Bulletin No: 99 RS1
Release Date: 4/1/99
Effective Date: 4/1/99
Supersedes:
Completion Date: As soon as possible
Page: 1 of 4

SERVICE BULLETIN

Ride Manufacturer: Zamperla Inc.	Affected Production Dates:
Ride Name: Rotoshake	Affected Serial Nos.: RS42F153US95
Model Number: Rotoshake

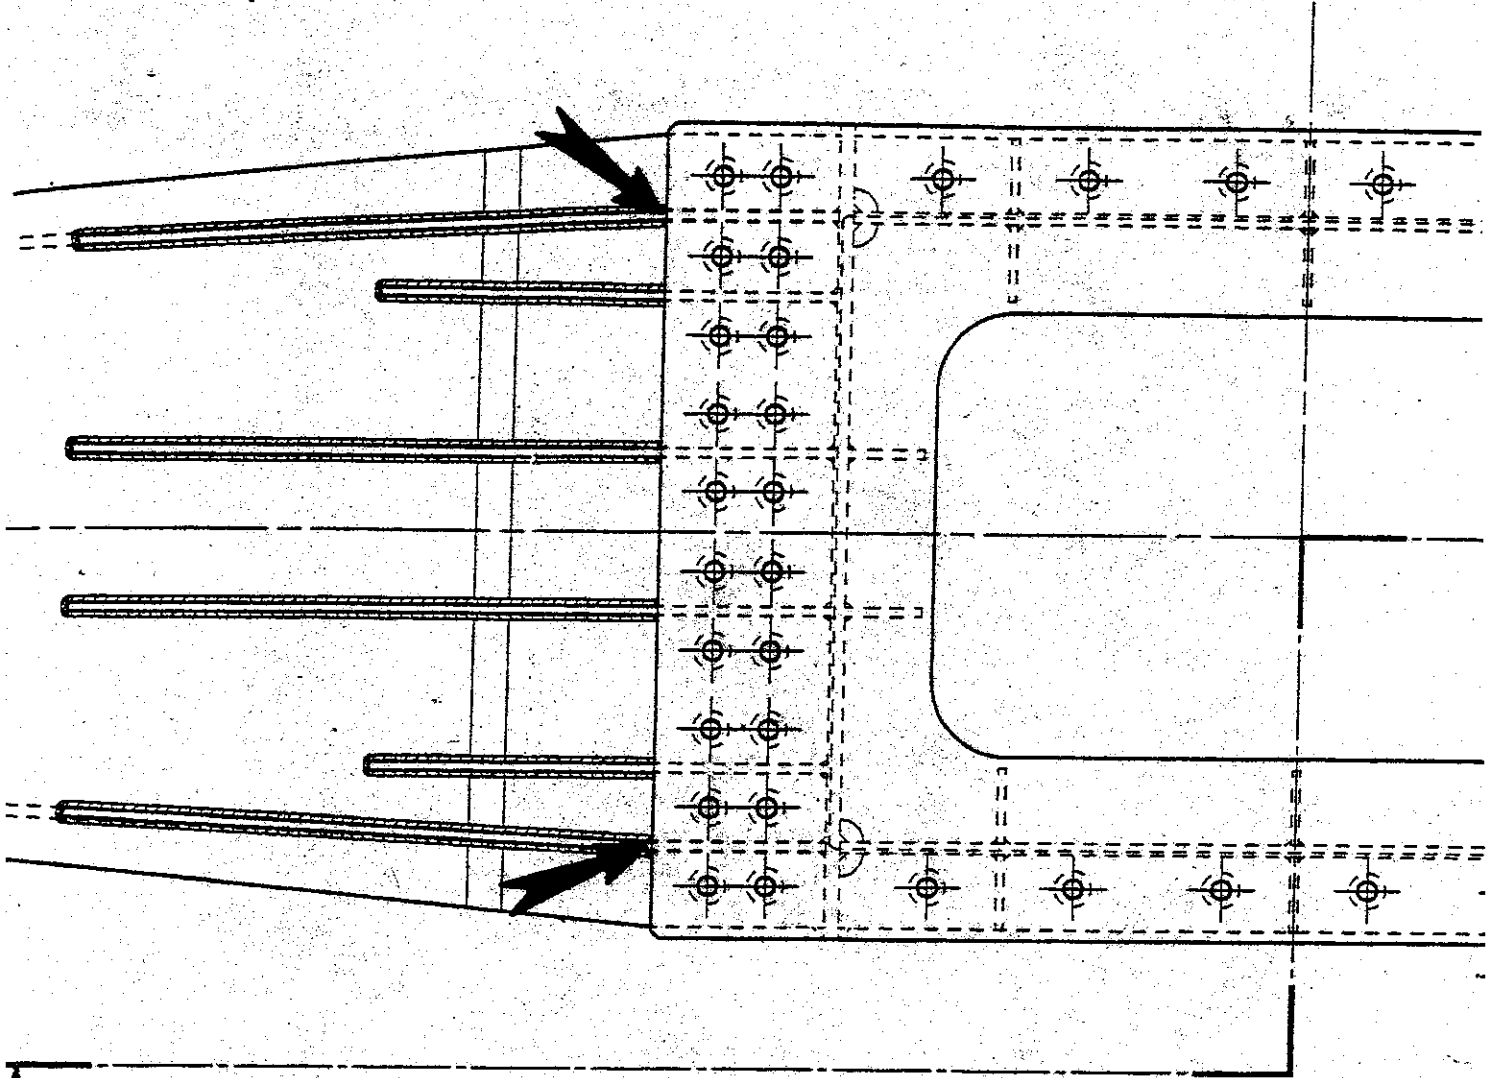
Abstract Of Issue:
Cracks have been found in the welds located at the connection of the fork arms to the central main arm.
See areas indicated on the accompanying diagram.

Action To Be Taken: Magnetic particle testing by a certified NDT technician

Detail Of Issue:
If cracks have been detected in the above mentioned welds and confirmed, please contact Zamperla Inc.
for Notification of repair procedure.

Future Action To Be Taken:
Magnetic particle testing by a certified NDT technician annually.

CONTROLLO MT89005 REV.A 100%
 MAGNETIC PARTICLE TEST MT89005 REV.A 100%
